Service information

Reference no.: SDA_89982

Mandatory - No communication between CPU and grinder sensor, grinder sensor wiring in wrong position

Image 1

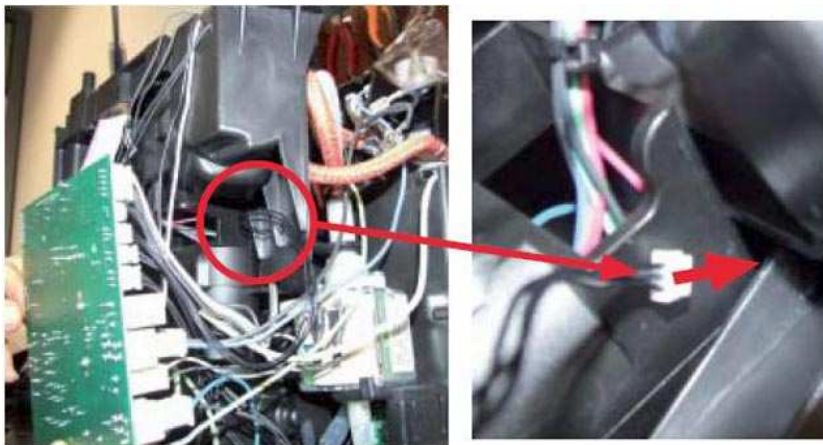
1°Problem : for incorrect positioning of the sensor wiring the grinder sensor is unplugged.

If the grinder sensor wiring is positioned like the pictures below (Image 1) :

Solution for the first problem: change the position of the grinder sensor wiring .

- remove the casing and remove the board (Image 2)
- insert the grinder sensor wiring in the cover's hole (Image 2)
- Pass the grinder sensor wiring in the hole indicated (Image 3)
- Plug the grinder sensor wiring at the sensor (Image 4)
